PARTS & SERVICE NEWS

REF NO.	AT03130
DATE	Jul. 17, 2003

SUBJECT: IMPROVED FIRE PREVENTION GUARD AGAINST OIL SPLASH ON HD785-3, HD785-5, HD985-3, HD985-5

Fig. 1

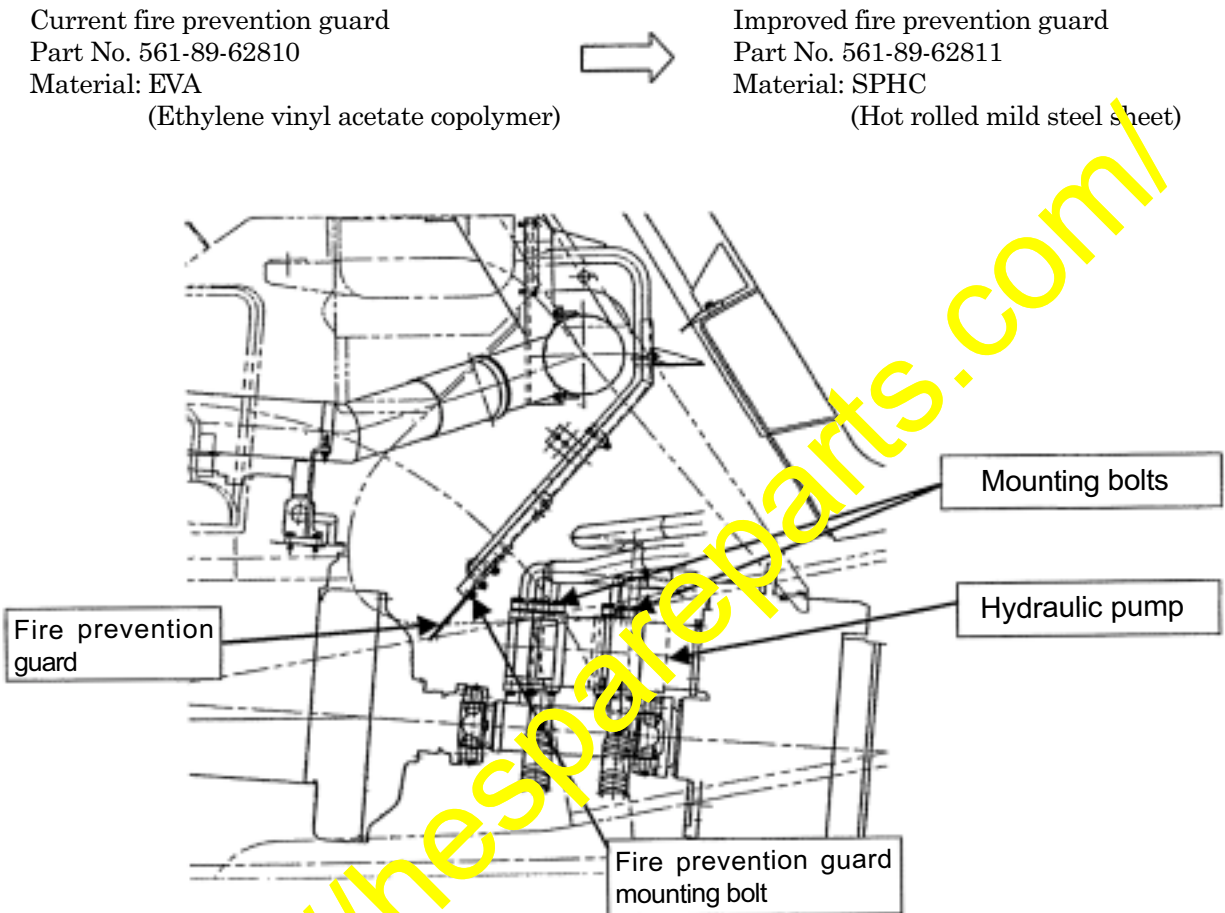
Since the currently used fire prevention guard being attached to the low end of the fire prevention cover may be affected and damaged by splashing oil coming out from the hydraulic pump, the material of the fire prevention guard has been changed to improve the quality of the guard not to be affected by splashing oil.

- (1) Remove the fire prevention guard mounting bolts (01010-81025) and remove the current fire prevention guard (561-89-62810).
- (2) Install the improved fire prevention guard (561-89-62811) using the fire prevention guard mounting bolts which have been removed as per the above Section (1).

Tighten the fastening bolts for the piping and hose connecting to the hydraulic pump at the tightening torque indicated in the table below.

However, if these bolts are tightened at an excessive torque, the threaded section may be damaged and these bolts may fall out causing oil splashes.
